Re Removal of asbestos based fire sprays from ceiling area above ACTEA David Jones and fire door Woden Plaza.

CONCEPT FOR REMOVAL OF ASBESTOS BASED MATERIALS.FILE No. **AO43**WODEN PLAZA.

CIVIL & CIVIC PTY. LTD.
NATIONAL MUTUAL CENTRE
CANBERRA CITY
CONCEPT FOR REMOVAL
OF ASBESTOS BASED
MATERIALS
WODEN PLAZA.

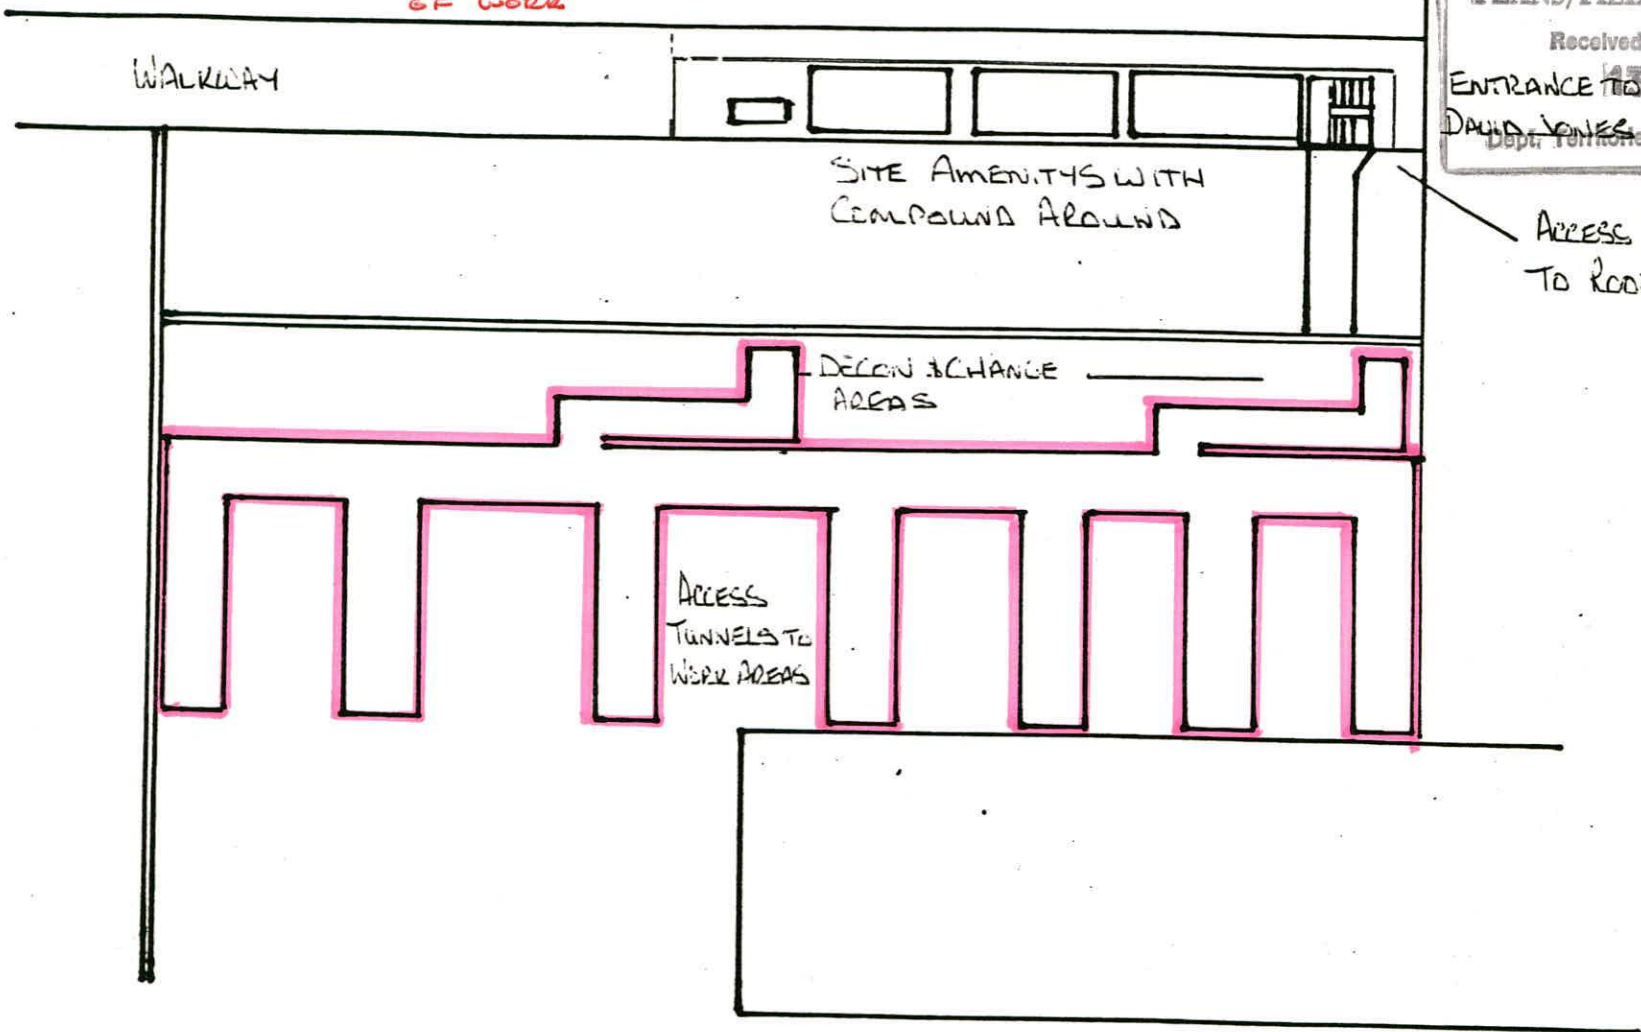
SUBMIT DETAILS OF PROPOSED METHOD
OF PROVIDING PROTECTION TO THE PUBLIC
AT STREET LEVEL, PRIOR TO COMMENCEMENT
OF WORK

Woden Plaza Layout

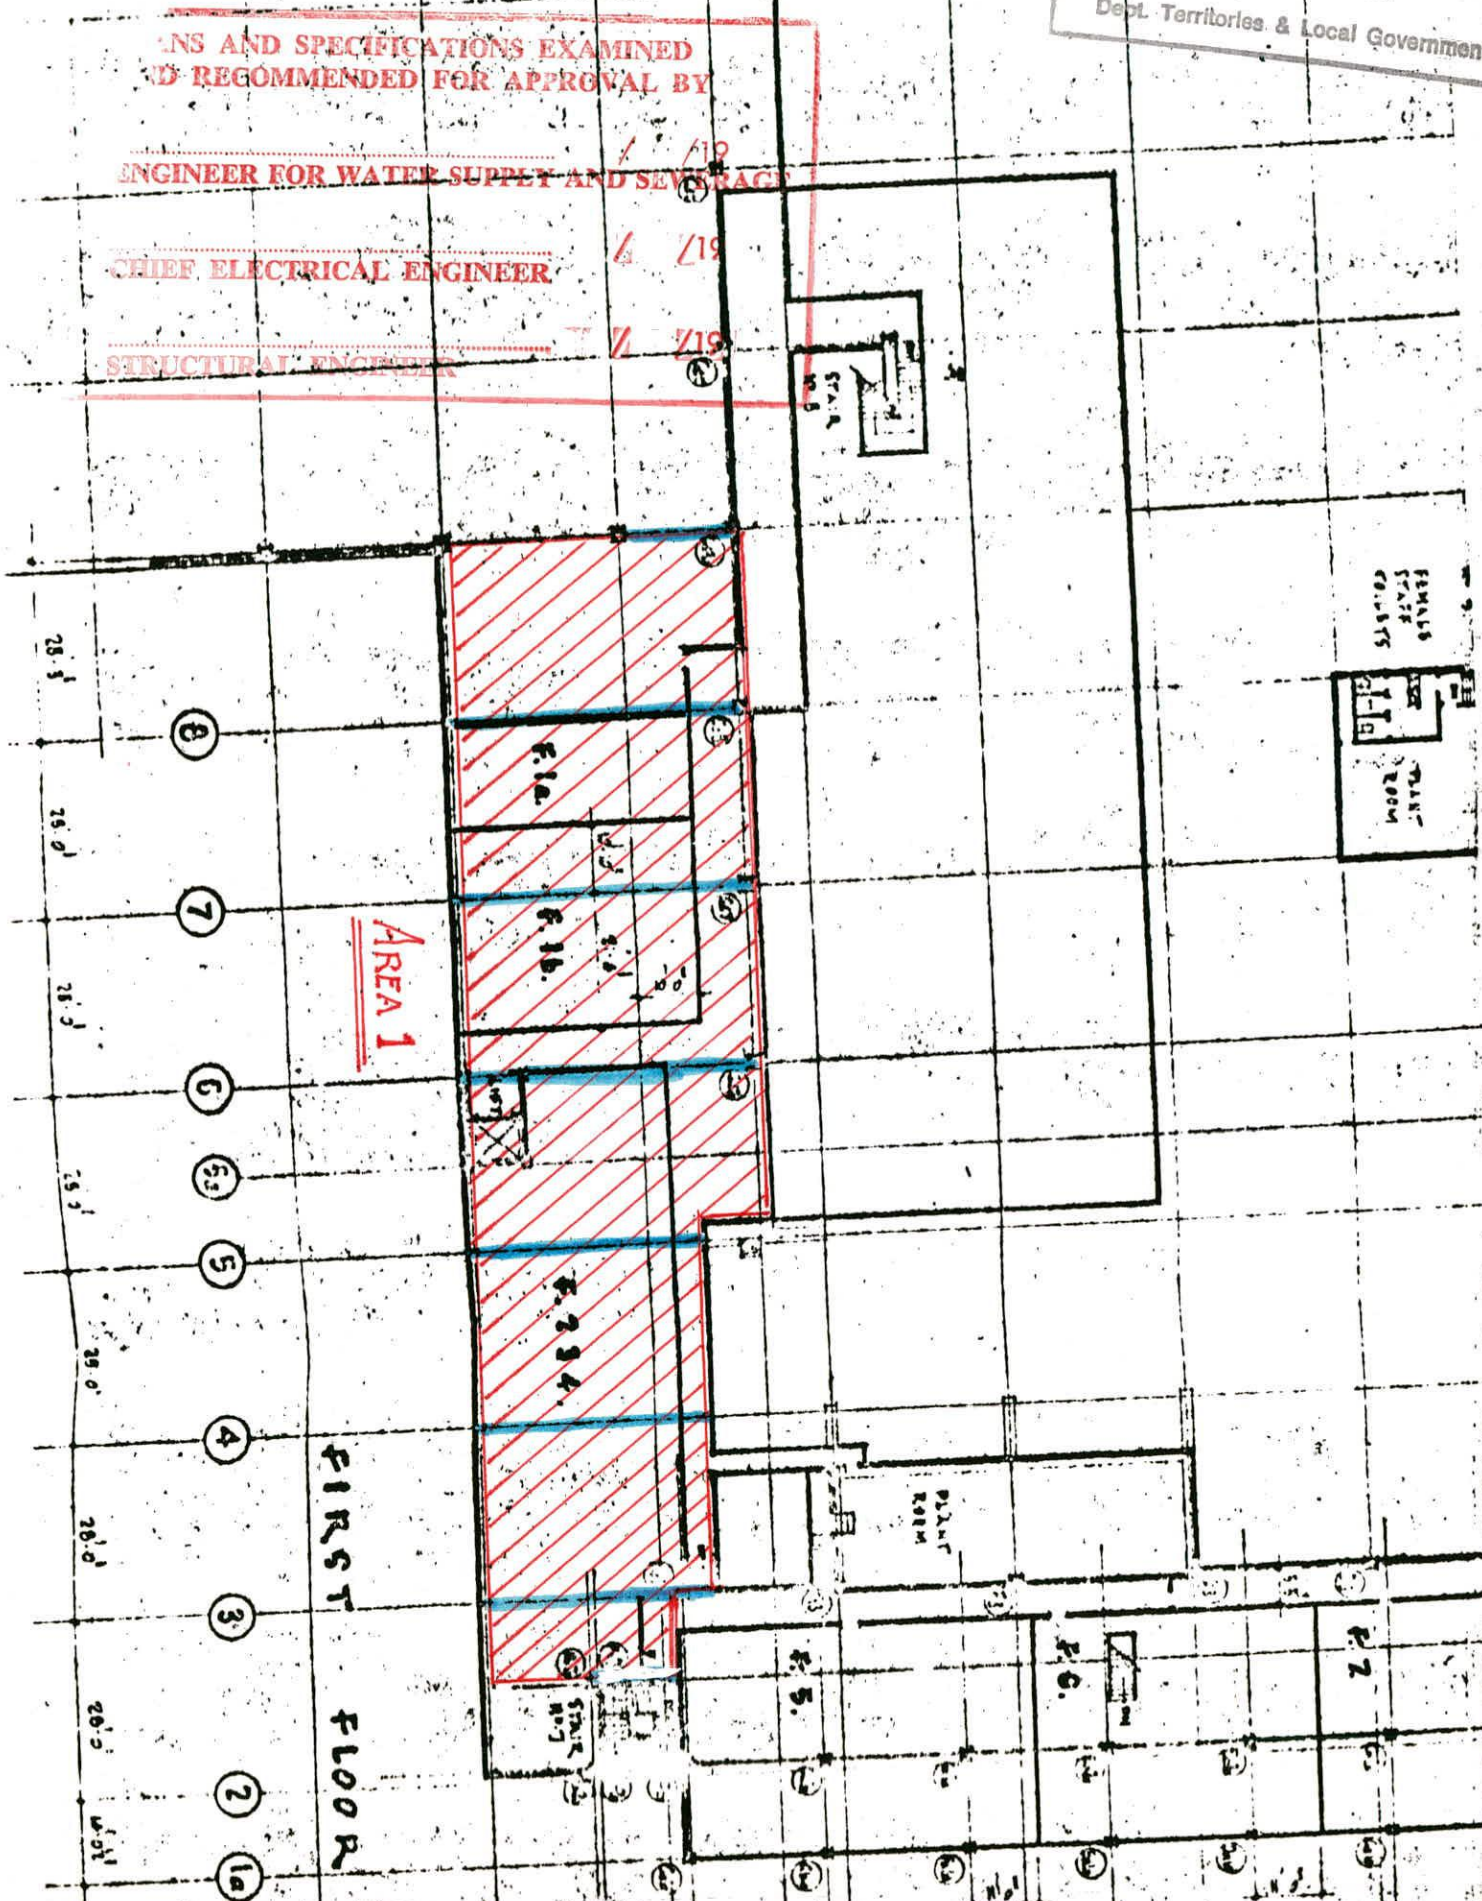
SUBMIT DETAILS OF DECON LOCATION
AND METHOD OF SEALING UNDERSIDE
OF REMOVAL AREA AND PROVISION OF
PROTECTION TO THE PUBLIC.
